# Town of Hilton Head Island Regular Design Review Board Meeting

March 8, 2016

PROJECT NAME: Improvements to Simmons Fishing Camp –  
ALTERATION/ADDITION

DRB#: DRB-002184-2015

## Wall Lamp

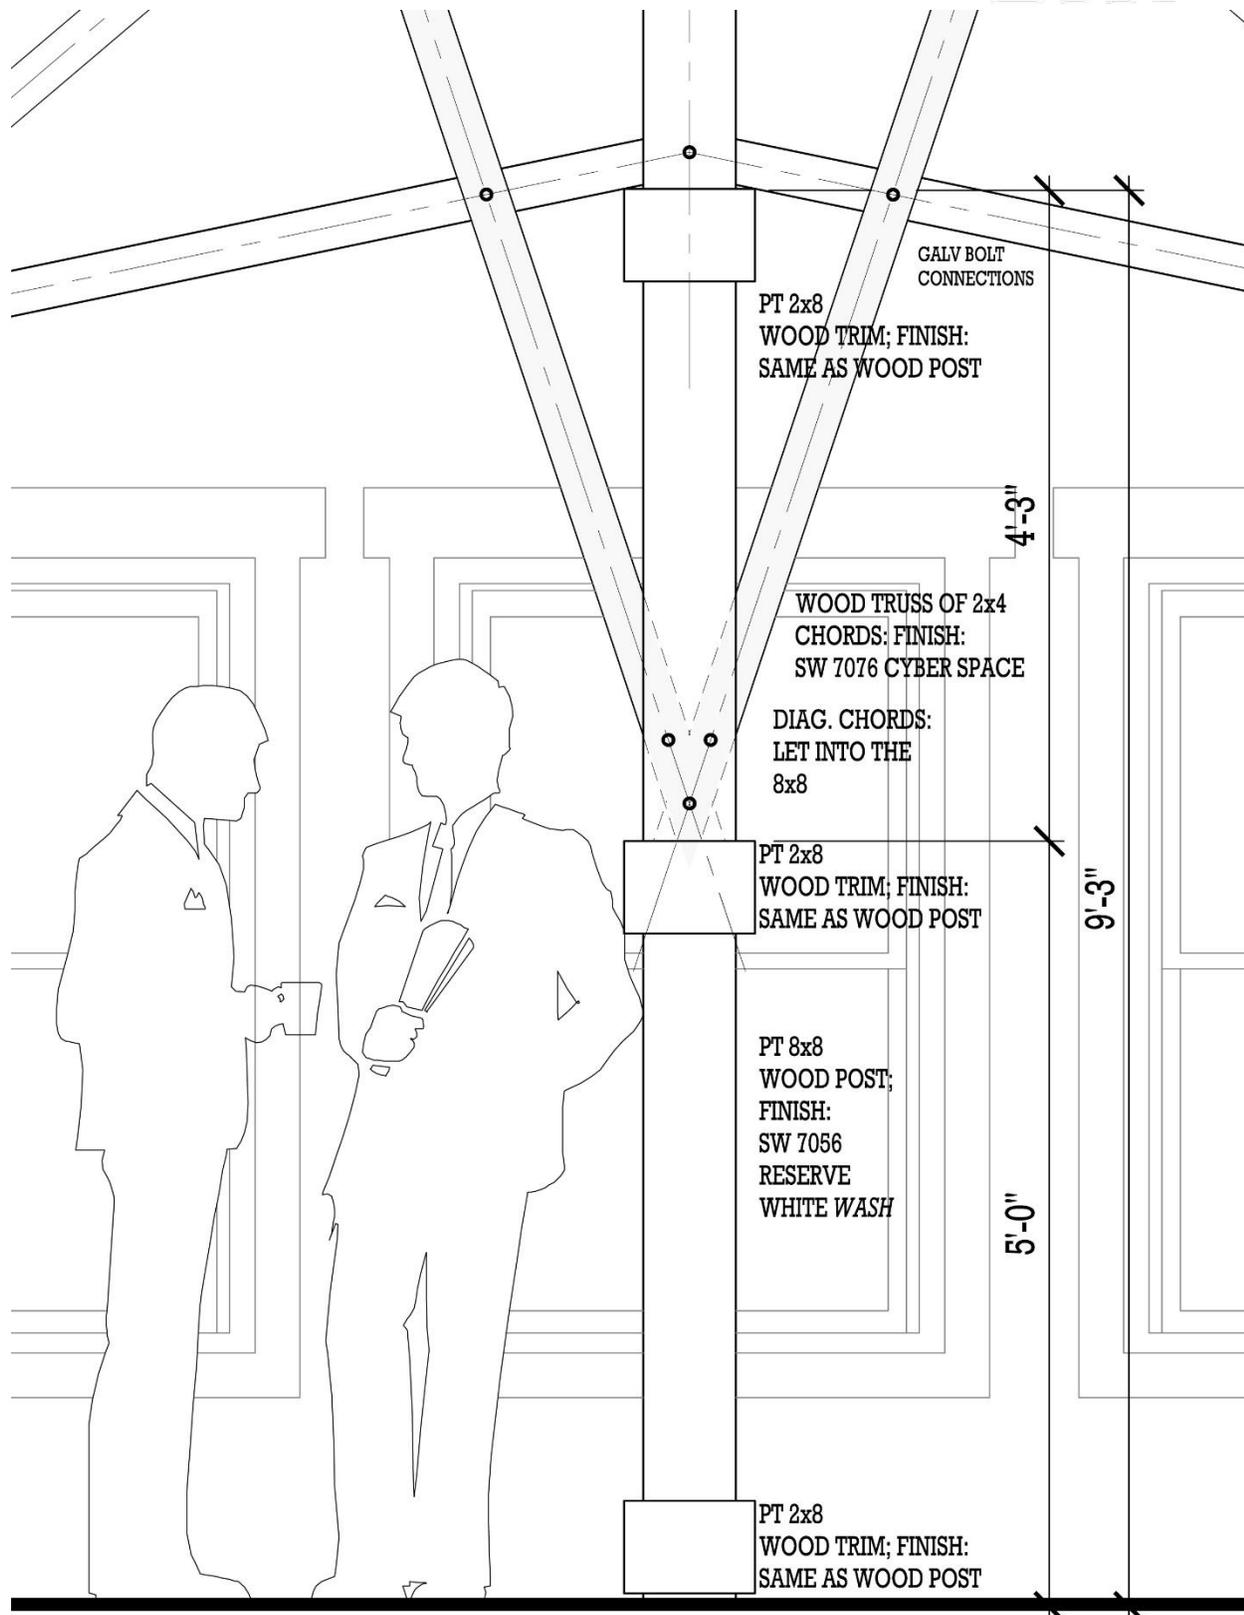
1. Provide lighting plan and clarify proposed light locations. Elevations indicate 4 wall lights.

The applicant has made revisions and addressed items 1, 2, and 4. The colors have been toned down from the original submittal and are in keeping the Design Guide. Wall mounted light fixtures (oil rubbed bronze) are proposed at front and rear entrances.

Proposed Main Level Floor Plan - 1/8"=1'-0"

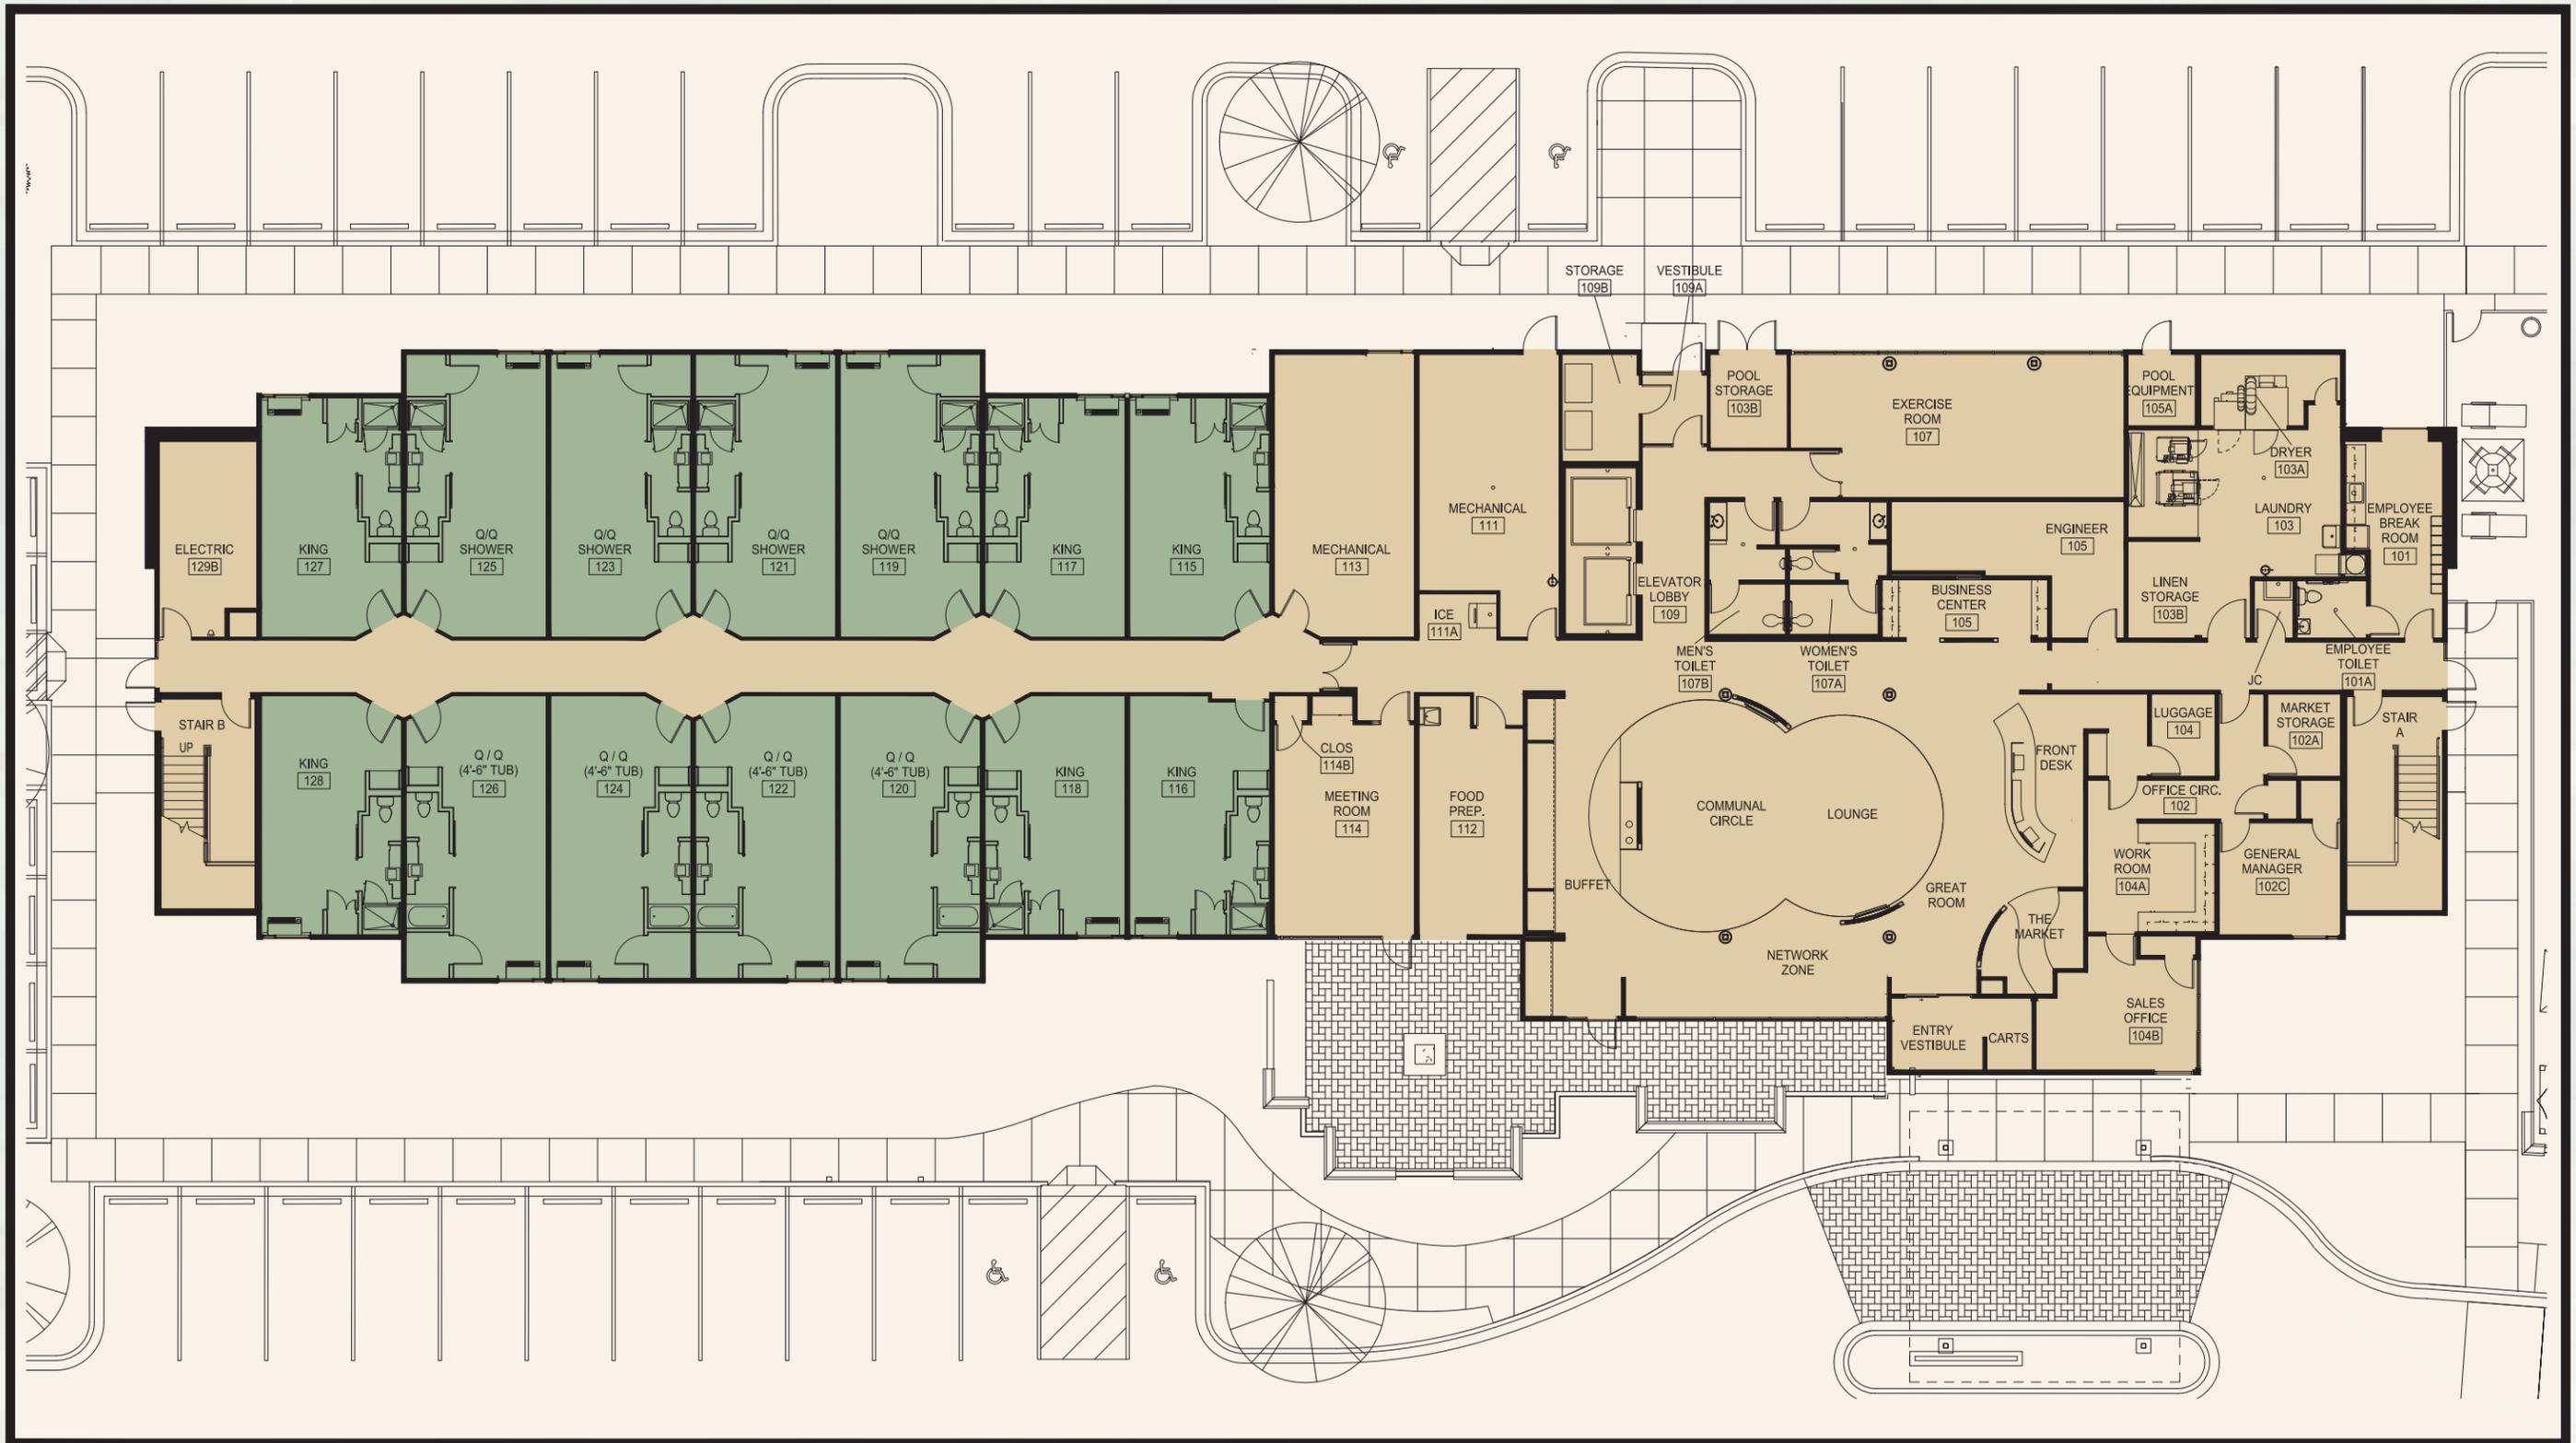
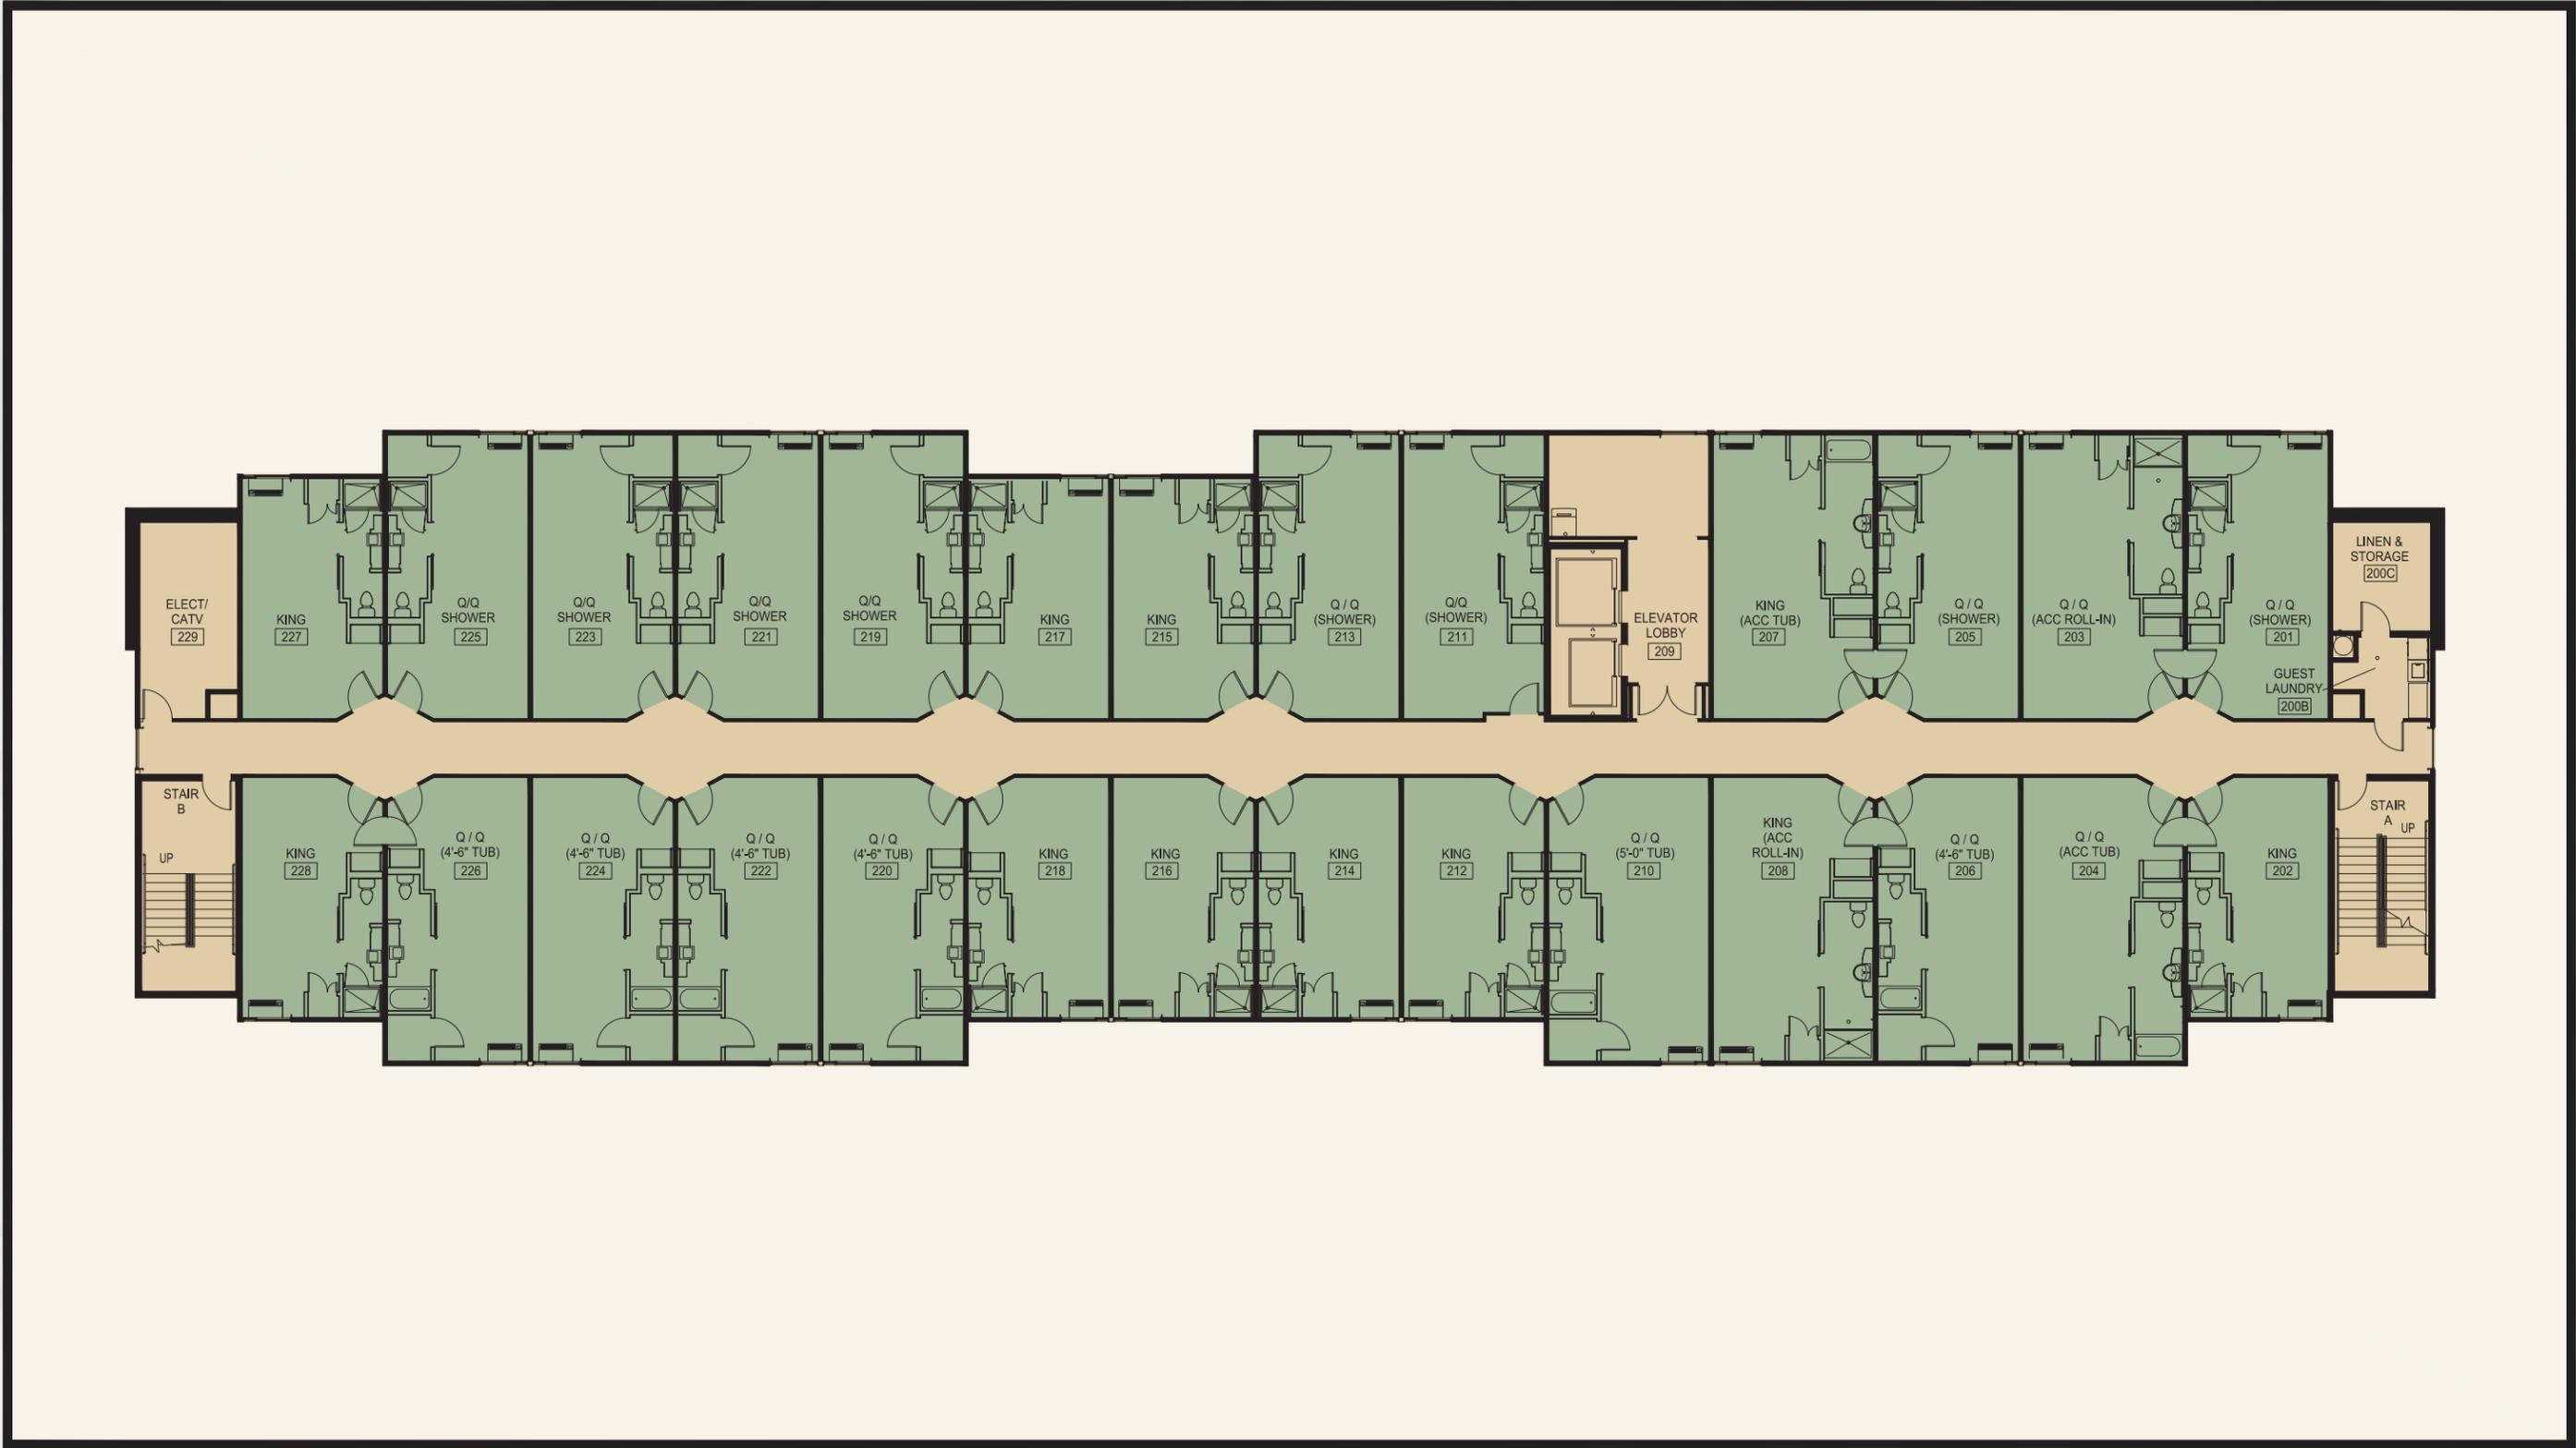
1. Consider how to utilize space where restaurant was proposed to loosen up site and provide more green space between building and parking.
2. Restudy entrance & location of porte cochere (adjacent to solid brick wall, not attached to building, not centered on elevation).
3. Reconsider use of stone on pool walls. Stucco, wood, or brick (or combination) would be more appropriate and in keeping with the Design Guide.
4. Restudy tower element in front & rear elevation.

The site development plan as submitted is over density allowed with all three buildings. According to the applicant the restaurant will be removed from plan.
